ORLANDO GATEWAY APARTMENTS

SUMMARY

Megan Barrow, AICP		
Updated: October 11, 2022	Public Comment Courtesy notices were mailed to property owners within 300 ft. of the subject property the week of Oct. 3. As of the published date of this report, staff has not received comments from the public.

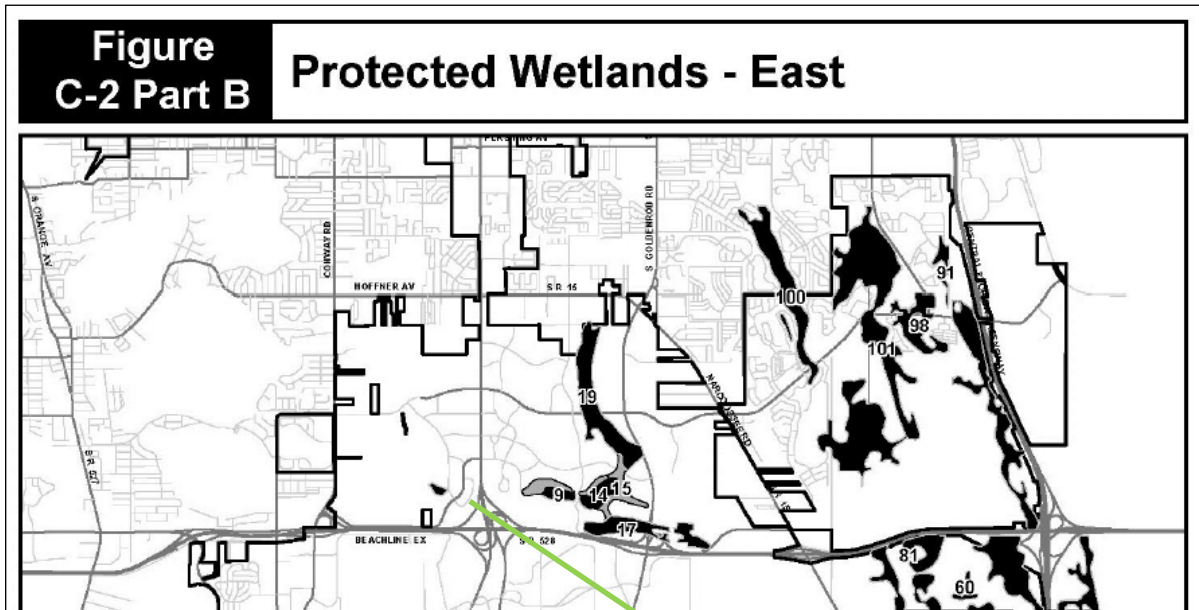
The Protected Wetlands map within the GMP’s Conservation Element map (Fig. C-2 Part B) shows a protected area in the direct vicinity of the subject parcels. (The subject parcels are discussed here as the northern, rectangular, 20-acre “Development Parcel” and the southern, triangle-shaped, 12-acre “Mitigation Parcel.”) These properties were annexed in 1985 and given development rights via AC-3 zoning in 1991, about the same time as the City completed its comprehensive wetlands study. Staff is tasked with interpreting the GMP policies, maps, and zoning development rights as they relate to the applicant’s proposal to impact protected wetlands.

When interpreting the GMP map via an aerial image, it is clear that at least part of the development parcel includes Protected Wetlands. It is not clear exactly where, nor how much. The aerial image shows a larger natural system surrounding Lake Mare Prairie that stretches east to Airport Lakes Park and southeast into the subject parcels, terminating (at least, above ground) at McCoy Road and SR 528. Airport Lakes Park is a 56-acre park developed with grant funds from Florida Communities Trust, a state fund for environmental resource protection.

The proposal to build multifamily residential is not a "low density [or] intensity" land use as allowed by the Tier One policy; to mitigate, the applicant has proposed a "wetland enhancement project" as allowed by the policy — a contiguous wetland area on the adjacent parcel, for no net loss of function. The development entitlements within the mitigation parcel will be ceded to Conservation land use.

Because impacts to Protected Wetlands are proposed, "mitigation above and beyond" is required; applicant has created a mitigation and maintenance plan that will be codified in a new GMP subarea policy.

Pre Vs. Post Wetland Area Exhibit

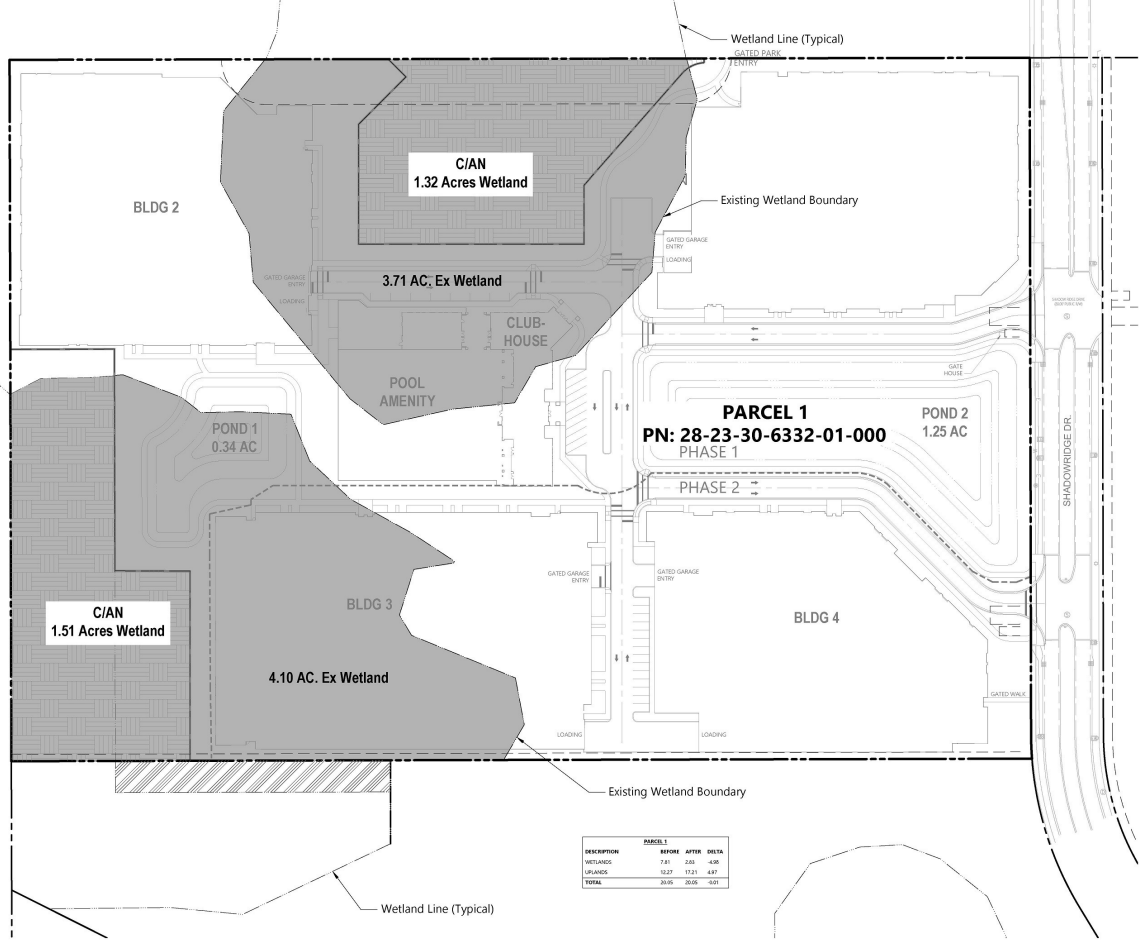
The site is required to include an average 25 ft. buffer as measured from the delineated wetland lines that must be maintained with native plantings consistent with GMP Conservation Policy 1.4.5.
